| Technical Information | Date: 02.07.2021 Official: Marier Department: BT-FIR/MKP3 |

| Tech. Information No. | 2366 / 2021 |
| Subject: | Connect remote services to redundant panels |

| Short Description: | The solution specified in the networking guide to connect remote services to a redundant AVENAR panel, will generate a fault condition. A temporary workaround is available |

Picture 1: Connection described in networking guide (version 1)

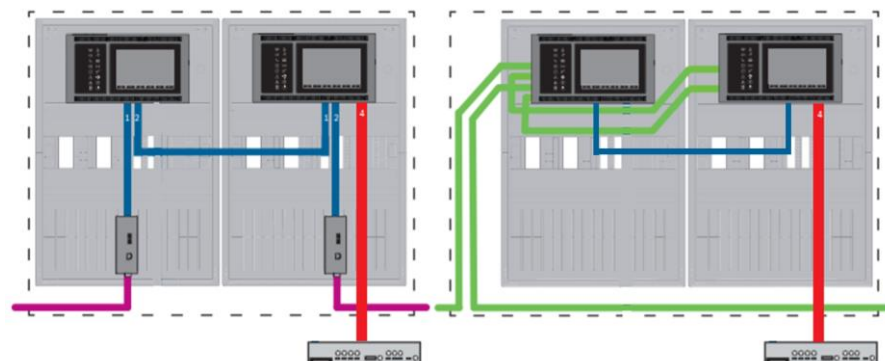
- Chapter 7.9 of the networking guide (08.2019|1|F.01U.378.914) illustrates how to connect remote service gateway to AVENAR panel equipped with a redundant panel controller.

- Because nothing is connected to ETH4 port of the redundant panel, an ETH4 fault condition will be generated. This is not only the case when you have a network of CAN or Ethernet, but also a stand-alone panel with redundancy
- A temporary workaround is connecting the remote service gateway only to the ETH4 port of the redundant controller, like shown on the picture 2 below.
- For CAN networking an Ethernet cable is additionally required between master and slave from ETH2 Master to ETH2 Slave

Picture 3: Settings in RPS

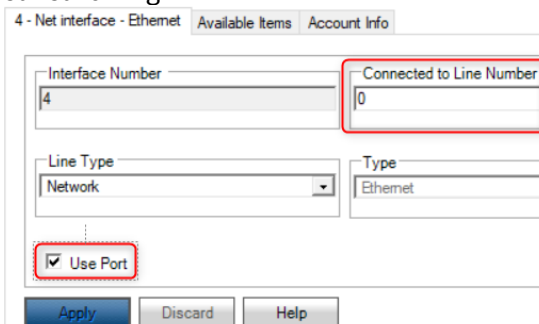
- In FSP-5000-RPS, the settings for ETH2 should be configured as followed (see picture 3), when using CAN networking:

Line number must be "above 0" to have the connection supervised

Picture 4: Settings in RPS

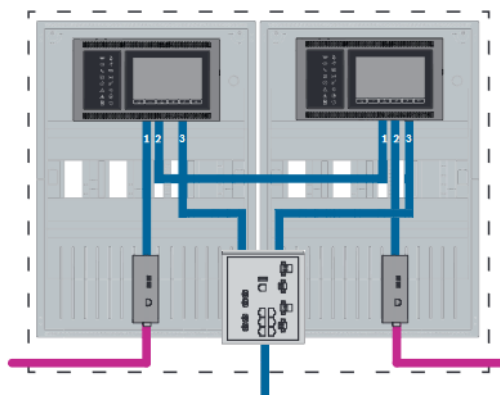
- In FSP-5000-RPS, the settings for ETH4 should be configured as followed (see picture 4), when using CAN and ethernet networking:

Line number must be "0" and "use port" should be marked
